N63 LISS TO ABBEY REALIGNMENT SCHEME

IN THE MATTER OF AN APPLICATION TO AN BORD PLEANÁLA
FOR APPROVAL OF THE N63 LISS TO ABBEY REALIGNMENT
SCHEME

ORAL HEARING

Part 2.1 – Response to Submissions & CPO Objections

Figure 3-1 Extract from EIAR A4.15, Junctions, Side Road, Pedestrian & Cyle Facilities Drawing – Sheet 4 of 7

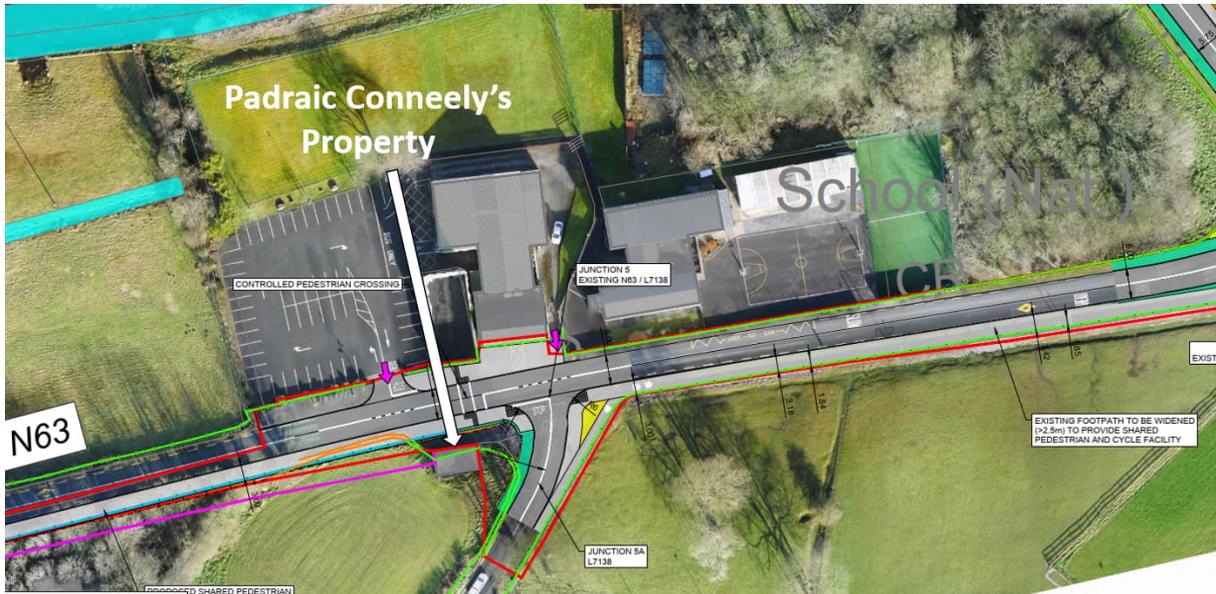
I object to this CPO order (No.1 2021, N63 Liss to Abbey Realignment Scheme from Galway County Council). The North part of my property, from my property to Chapel Road, is bounded with a stone wall on part with a ditch and a Blackthorn hedge on the remaining part. These features cannot be removed.

The permanent and temporary land take, along with the proposed boundary treatment, are detailed below in Figure 3-2 as extracted from the EIAR.

As is seen in the drawing, the stone wall and fence to the West of the property along the existing N63 will be removed to allow for construction of the proposed footpath. In the interest of clarity, it is noted that this existing wall and fence are indicated by the brown lines on the west of the property in the figure below, as per the drawing legend. The temporary land take is required for the construction of the new proposed fence and proposed pedestrian facilities. The area of temporary land take will be reinstated to match previous condition where feasible after construction of the scheme works.

The short section of green line immediately to the West of the property indicates a section of existing wall and fence that will be maintained and will connect to the new main scheme boundary along the main road.

The section of green lines to the East of the property, continuing down “Chapel Road” (L7138) represent a wall/fence which will be maintained as a part of proposed development.

The section of hedgerow running along the existing N63 will be removed to allow for the construction of the new footpath.

Figure 4-2 Extract from Appendix C – Additional Drainage Detail at Rose Villa

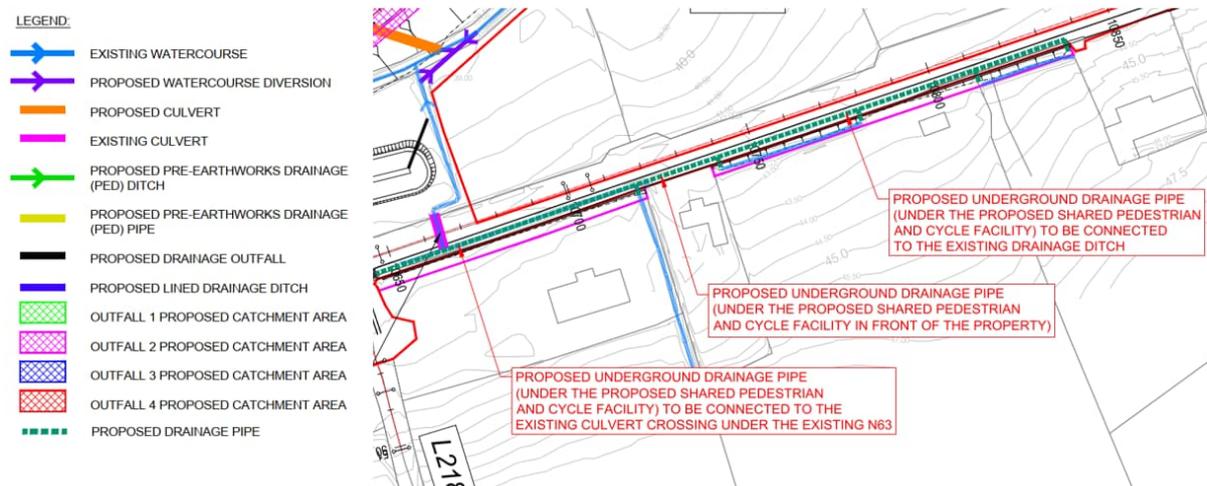
- Plot 116A.004 is referenced as temporary take. Figure A4.13 – Junctions, Side Roads, Pedestrian and Cycle Facilities Sheet 2 of 7 shows earthworks fill to back of proposed footpath and lined drainage ditch is also proposed behind earthworks fill. Temporary land take is usually used to facilitate construction of the permanent infrastructure and lands are returned as they were before to the landowner at the end of the work. This does not appear to be the case here, this must be clarified.

The temporary land take to the east of the dwelling (plot 116A.004) is required for the construction of the new proposed fence and proposed pedestrian and ancillary facilities. There is no requirement to match the existing condition of the area at the end of the temporary acquisition but, in this case the area of temporary land take will be reinstated to match the previous condition so far as feasible following the completion of construction. It's not intended to modify the operation of the existing ditch running at the back of the proposed footpath. The earthworks shown in the proposed design will only be required to tie in with the existing drainage and will be minimised as much as possible.

There is no lined drainage ditch proposed within this area of temporary land take. Figure 4-2 below is an extract from Appendix C – Additional Drainage Detail at Rose Villa. The blue line within the temporary land take area represents an existing watercourse.

Figure 4-4 Footpath, parking and pedestrian crossing arrangement proposed in submission

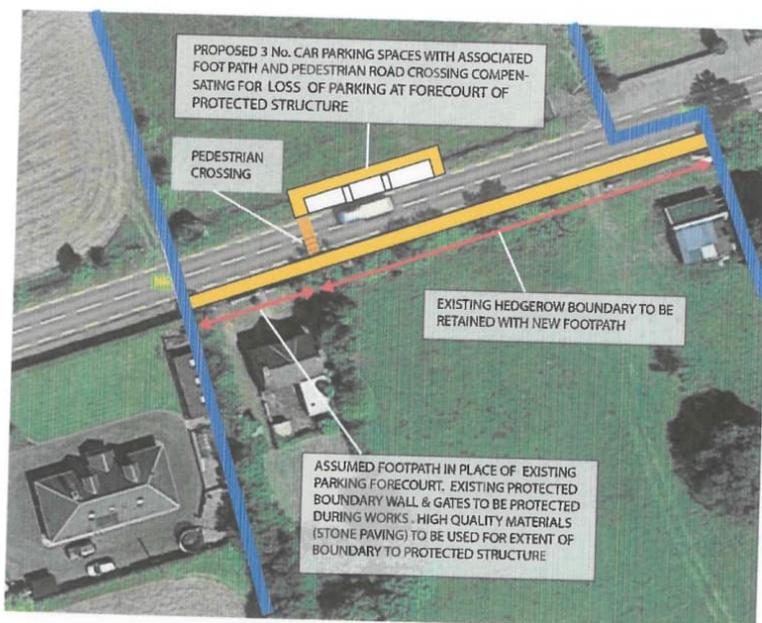
Item 1 - We note that our client's use of the property is not properly recognised in the works as proposed. Our client uses the forecourt to the existing dwelling as a parking area. The proposed works will remove the forecourt car parking area and as such this will disadvantage our client and diminish the use of the property. We request that the design is revisited, and that three parking spaces are incorporated on the northern side of the of the road located to the east of the dwelling frontage. We also request that a crossing point and footpath to the car parking is provided. We also request that the traffic speeds on the existing road will be reduced to 30km / hour. We note that there are a number of advantages to this proposal.

- The provision of car parking spaces will ensure that our clients use of the property is not diminished.
- The provision of parking on the street, and a crossing point between the north and south will reduce traffic speeds. This is in accordance with the Design Manual For Urban Roads and Streets (DMURS).
- The provision of a crossing point from the northern side of the street to the south will provide safe access across the road for the existing dwelling to access the northern lands on foot.

In relation to the permanent land take plots 116B.002 and 116B.003, these are classified as roadbed areas and comprise part of the public road. These roadbed areas are in the charge of GCC and are maintained by GCC.

In relation to the provision of a crossing point in front of Rose Villa, there is a controlled pedestrian crossing for the existing N63 proposed to the east of the property at the Community Centre. There is no basis for providing the three car parking places suggested on the part of Ms. Wood or to give her an individual pedestrian crossing. Traffic on this road will be greatly reduced from present levels due to the road scheme proposed herein. In addition Ms. Woods will have far improved pedestrian and cycling facilities outside her wall as well as improved sight distances to and from her entrance. Ms. Woods also has a driveway to her property with car parking along same. There is no justification for a crossing point (or parking) at this location. Access to Ms. Woods's driveway and pedestrian entrance (as well as to her agricultural holding) will be maintained both during construction and operation of the scheme.

The design speed for this section of road will be 50kph and is in accordance with DMURS. Reducing the speed to 30kph is considered unnecessary and unjustified and is not required by DMURS.

The design changes proposed as a part of this submission can be seen in Figure 4-4. We note that the comment "Existing hedgerow boundary to be retained with new footpath" as stated on behalf of Ms. Woods is incorrect in relation to the design for the proposed development. Further clarification into the boundary treatment is given in the response in section 4.4.3.1 above.

Proposed footpath, parking and pedestrian crossing arrangements to the front of Rose Villa

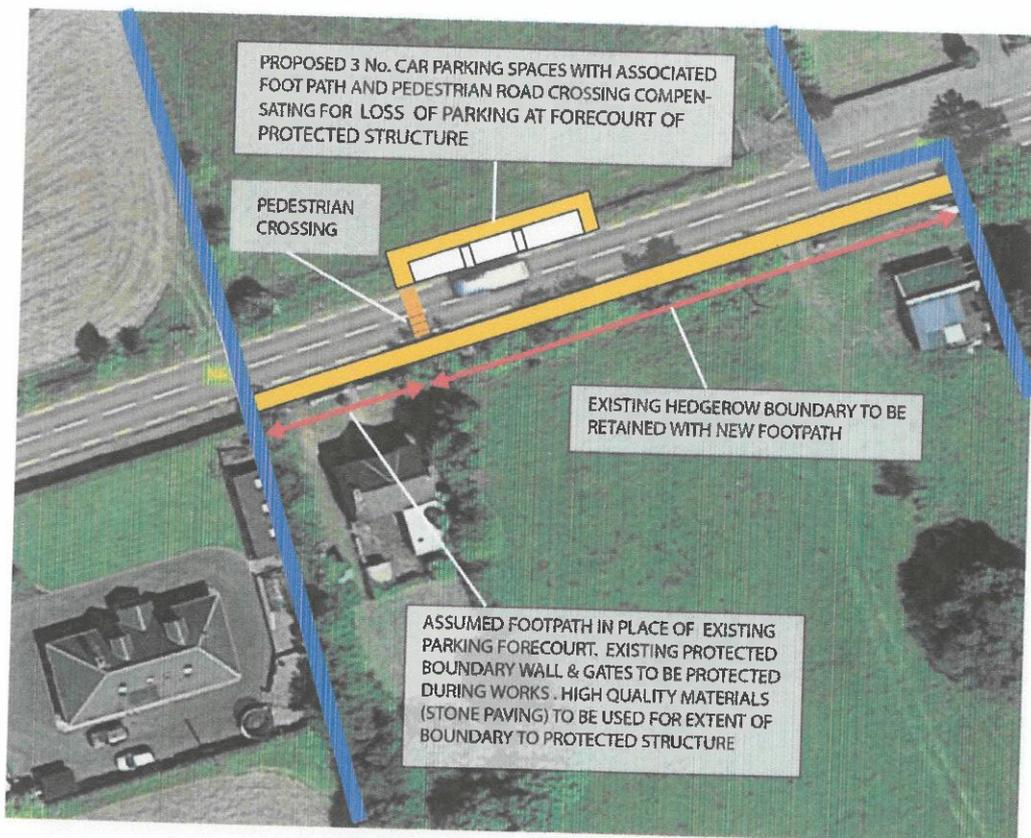
Item 1 - We note that our client's use of the property is not properly recognised in the works as proposed. Our client uses the forecourt to the existing dwelling as a parking area. The proposed works will remove the forecourt car parking area and as such this will disadvantage our client and diminish the use of the property. We request that the design is revisited, and that three parking spaces are incorporated on the northern side of the road located to the east of the dwelling frontage. We also request that a crossing point and footpath to the car parking is provided. We also request that the traffic speeds on the existing road will be reduced to 30km / hour. We note that there are a number of advantages to this proposal.

- The provision of car parking spaces will ensure that our clients use of the property is not diminished.
- The provision of parking on the street, and a crossing point between the north and south will reduce traffic speeds. This is in accordance with the Design Manual For Urban Roads and Streets (DMURS).
- The provision of a crossing point from the northern side of the street to the south will provide safe access across the road for the existing dwelling to access the northern lands on foot.
